**ROCKFORD BOARD OF EDUCATION  
INVITATION FOR BID ON SUPPLIES, MATERIALS, EQUIPMENT OR SERVICES  
FOR SCHOOL DISTRICT NO. 205  
ROCKFORD, ILLINOIS**

IFB No.        **17-40 Rockford Public School District 205 School B, Zone 1**

RE:        **ADDENDUM NO. 7**

Rockford Public School District 205  
School B, Zone 1  
Rockford, IL  
Cannon Project No. 005005.00

**WORK AREA OVERVIEW PLAN**

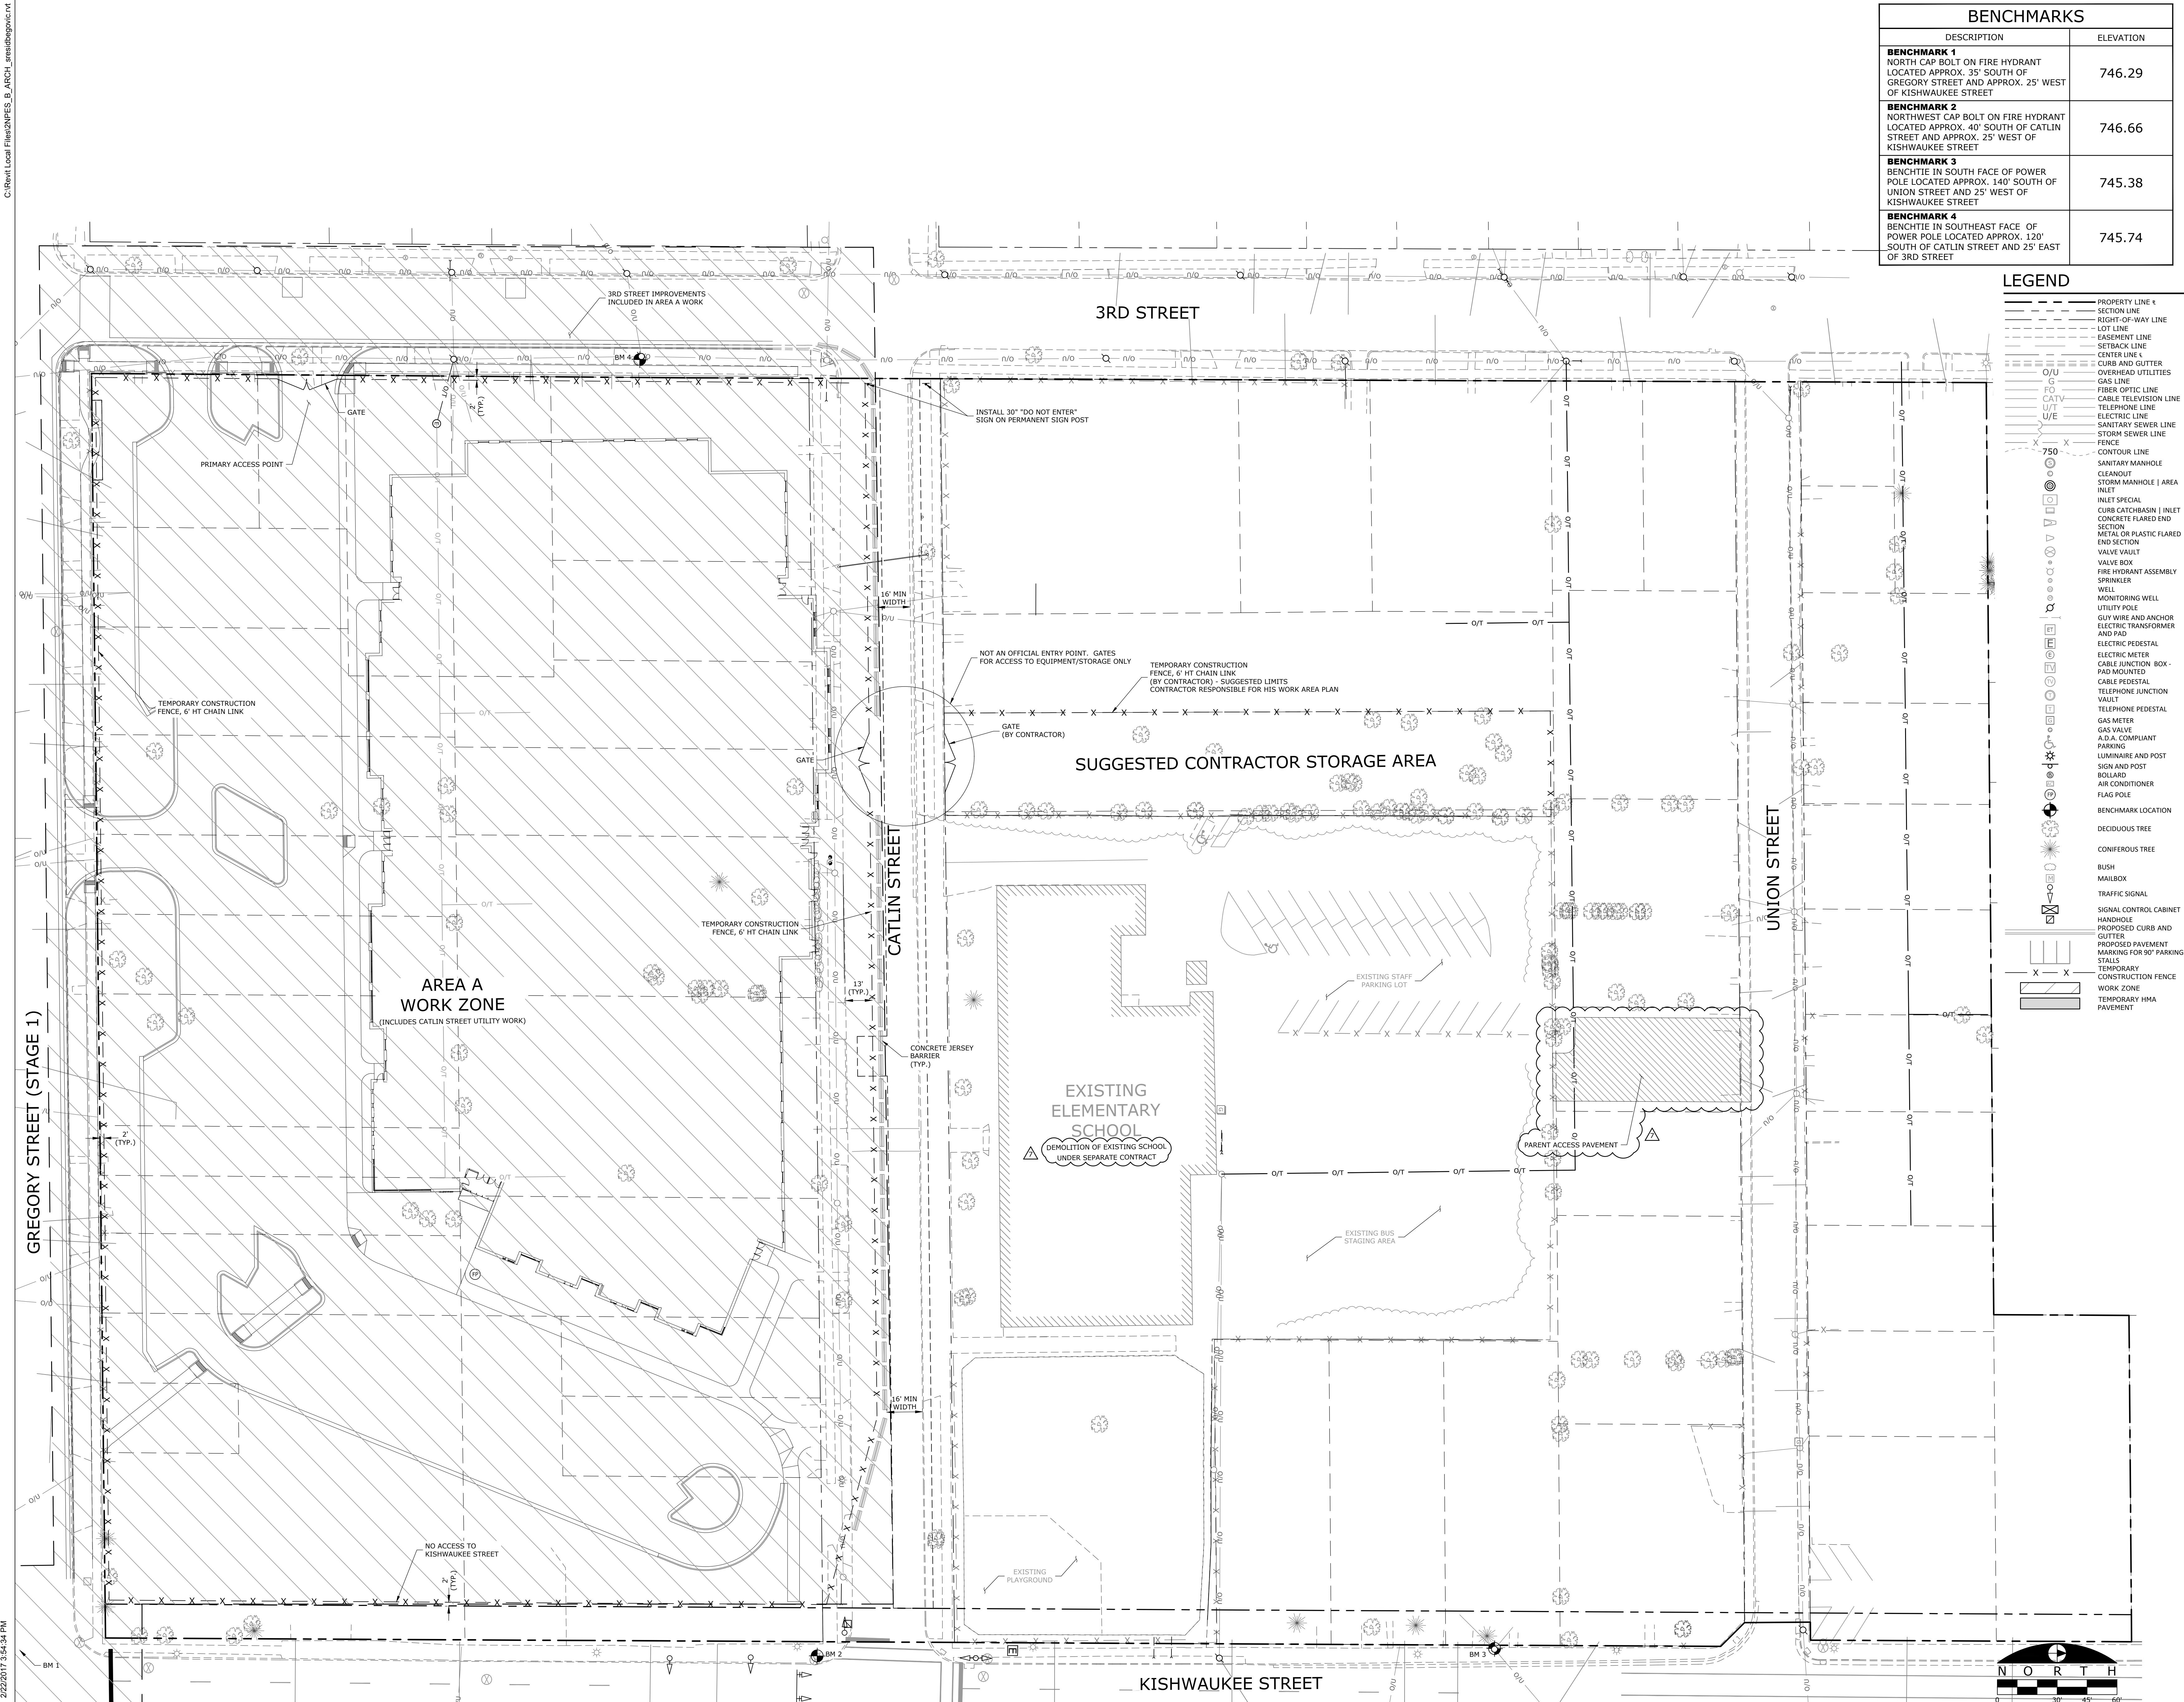
1. C04 - WORK AREA OVERVIEW PLAN

- A. Revised scope of work summary

**C05**

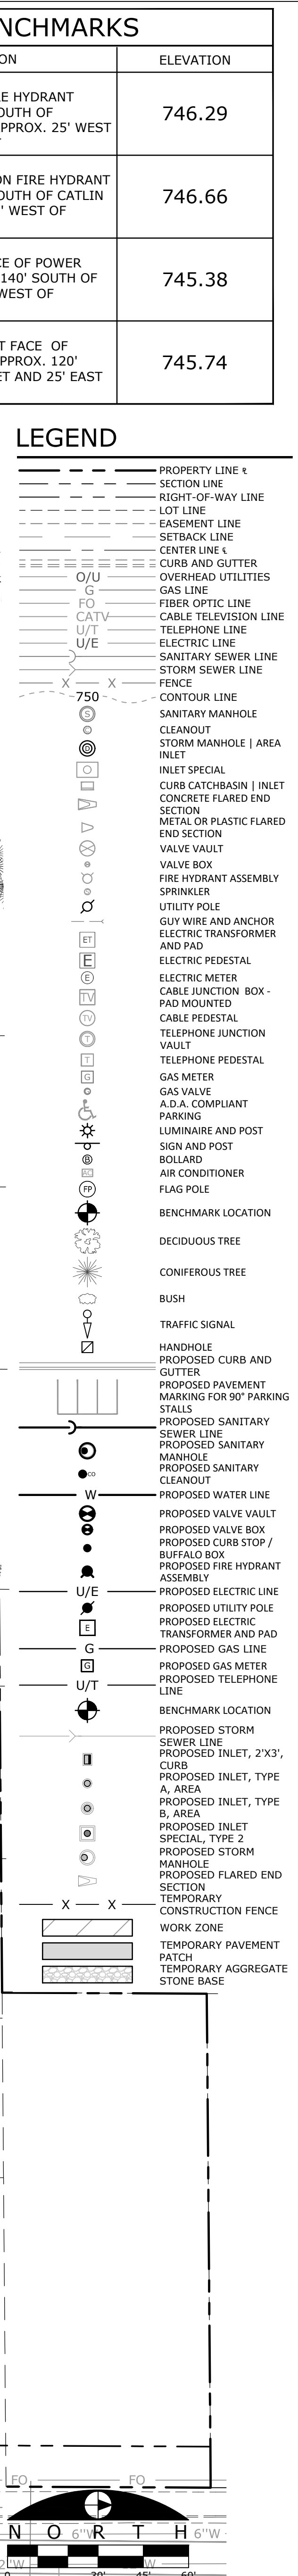
2. C05 - AREA A WORK SCOPE

- A. Revised notes to eliminate reference to dates.

# C06

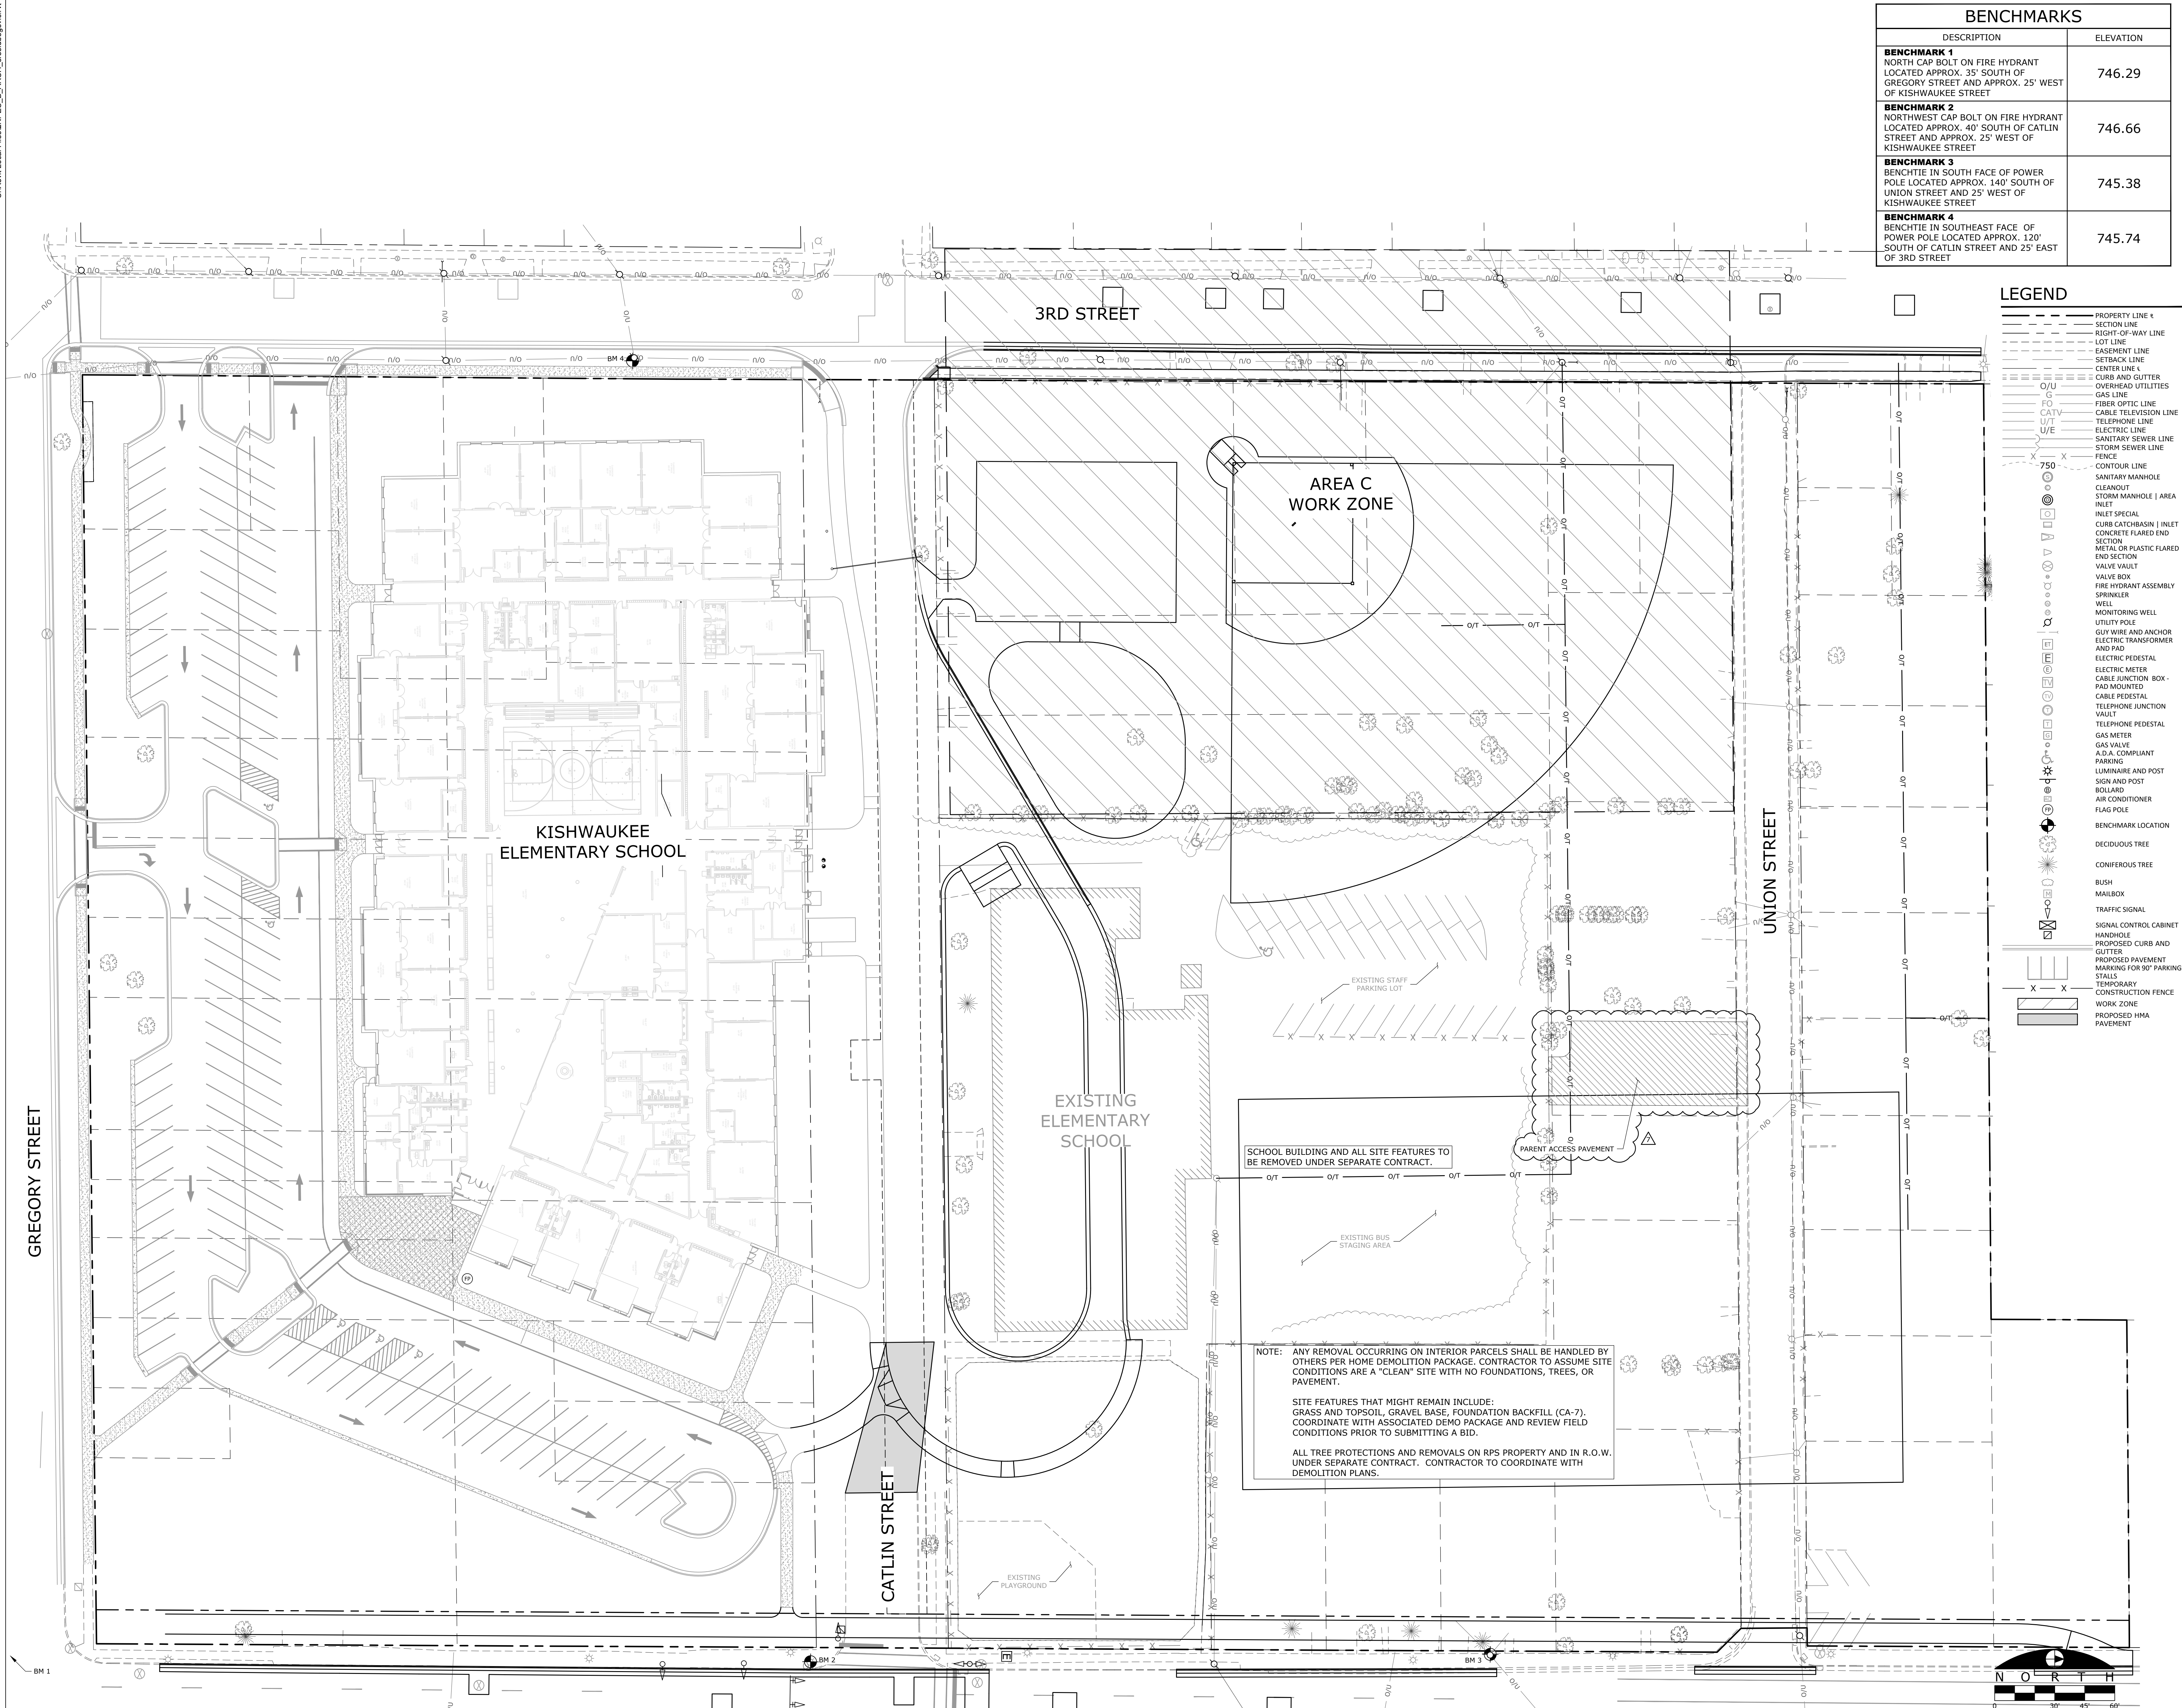
3. C06 - AREA B WORK SCOPE

- A. Revised notes to eliminate reference to dates.
